RE: Section 92 responses

Memorandum

Subject: OceanaGold Coronation North Project – ORC s92 request for further information

Figure 39 Number of flathead galaxiids (per 10 m reach) found in summer surveys of Deepdell Creek, 1995 to 2015.

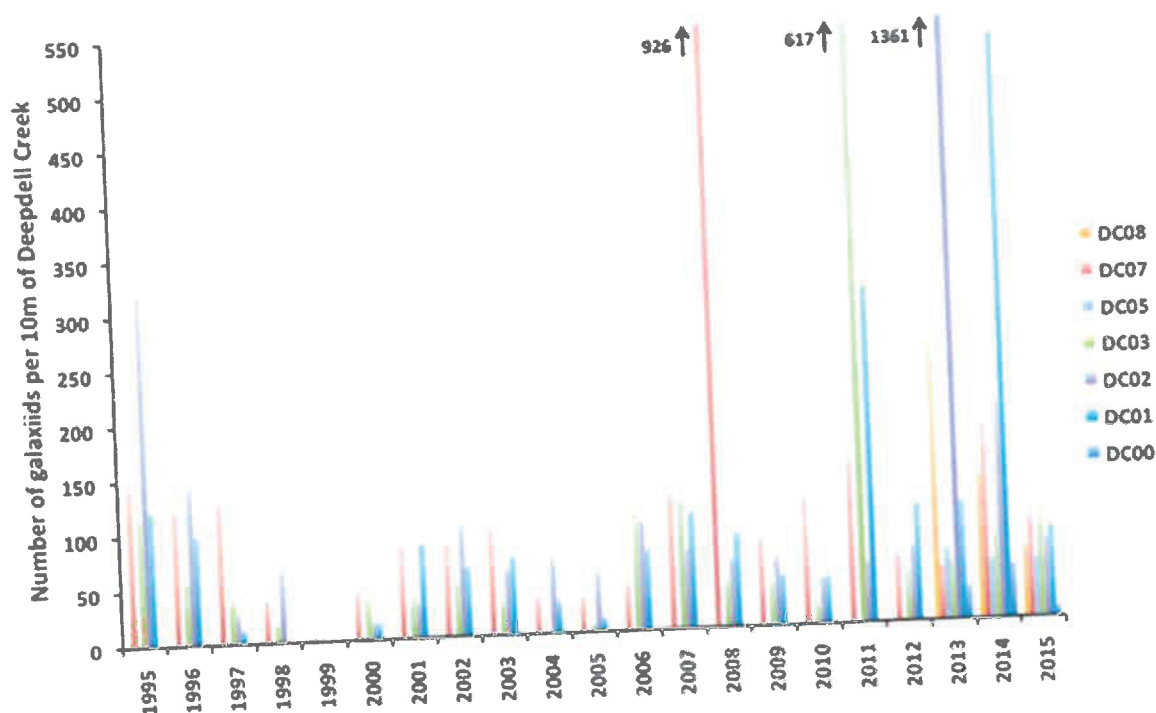
Deepdell Creek is arguably the most monitored stream in Otago. Galaxiid abundance and recruitment in this creek and other nearby creeks has remained stable, although quite variable from year to year (see chart below), suggesting existing water quality criteria are working for fish populations.

Turbidity vs flows in Deepdell Creek prior to March 1993 (initial construction period). Source: B. Sinclair, Golder Associates (NZ) Ltd.

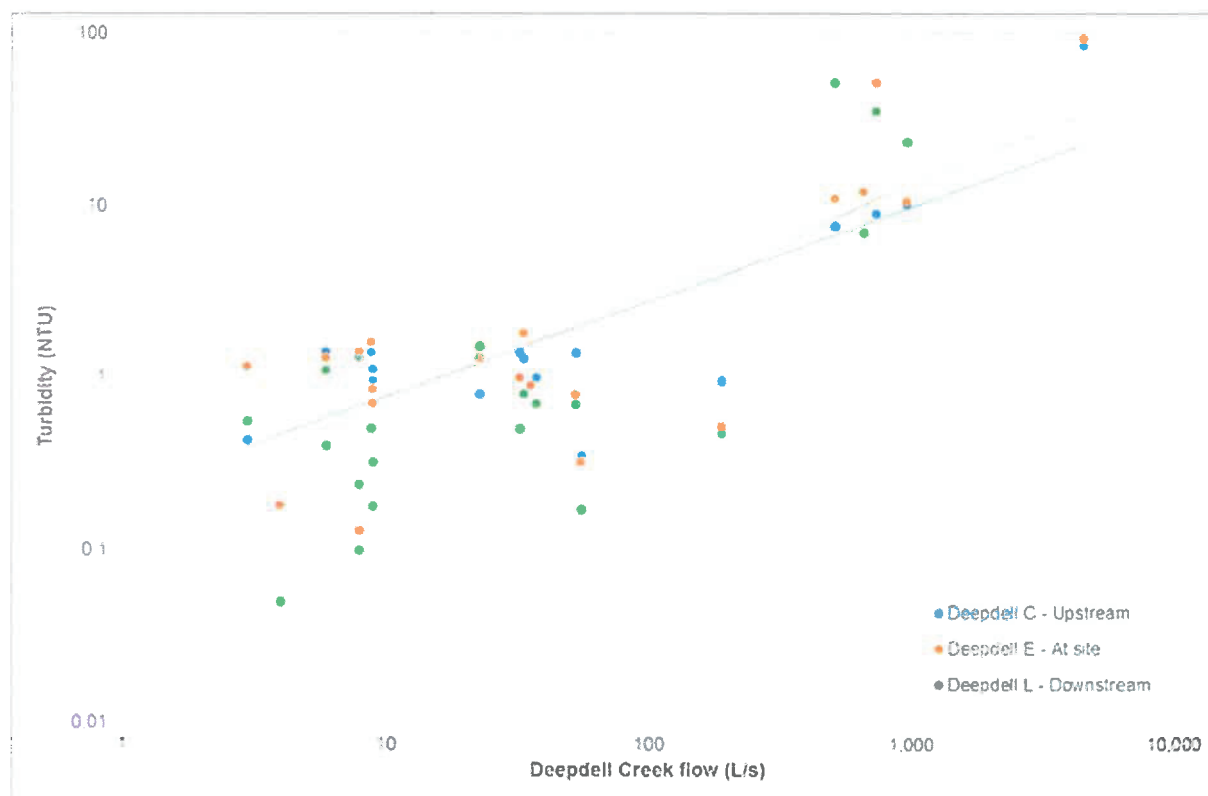
On page 5 of the NIWA review, the section on sediments mentions that there is no monitoring data to support the statement that the existing management procedures have worked well. Brett Sinclair (Golder Associates) has provided me with a chart of turbidity versus stream flow in Deepdell Creek prior to March 1993 (see chart below). This chart indicates that the initial construction work for the mine did not affect stream turbidity at that time.

Quarterly surveys of sites throughout Deepdell Creek since the early 1990s (including macrophyte and periphyton cover assessments, together with photo records) indicate that sites downstream of the mine continue to be dominated by small boulders and cobbles. Fine sediment accumulation has not been an obvious feature at these sites. It is our experience that streams draining the Macraes Gold Mine typically have good clarity in medium to low flow conditions.

While we have not monitored fine sediment cover or sediment embeddedness in a quantitative manner as a part of routine monitoring, it is a method that could be included at stream monitoring sites with a minimal amount of additional time required.
